SERVICE 2558D TELEPHONE SETS

1.01 Reissued to:

♦Fig. 1—2558D Telephone Set Connections (Factory Wired) ♦

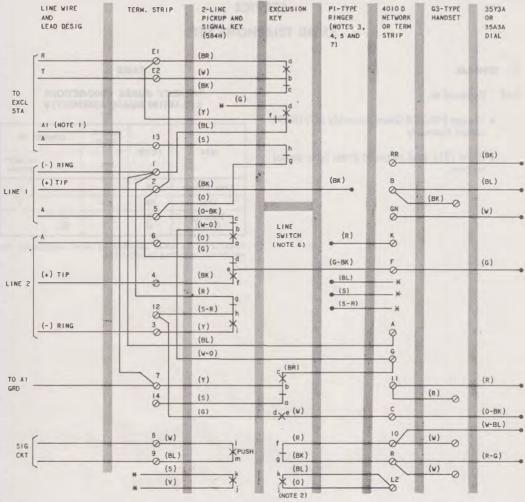
- Change P-90D053 Guard Assembly to D-180190 Guard Assembly
- Show (BL) lead removed from later model ringers

4. SETS ARE FACTORY WIRED FOR BRIDGED RINGING SERVICE, CONNECTIONS FOR PIB SAME AS
- PIA RINGER. (BL), (S), AND (S-R) LEADS SHOWN INSULATED AND STORED ARE ON PIA ONLY.
- 5. TO SILENCE RINGER PERMANENTLY, REMOVE (BK) RINGER LEAD FROM TERMINAL 2, INSULATE AND STORE.
- 6. LINE SWITCH SEQUENCE. HANDSET REMOVED:
- bc-MAKES ab-BREAKS de-MAKES fg - MAKES
 - 7. (BL) LEAD HAS BEEN REMOVED FROM LATER MODEL RINGERS.
 - * INSULATED AND STORED
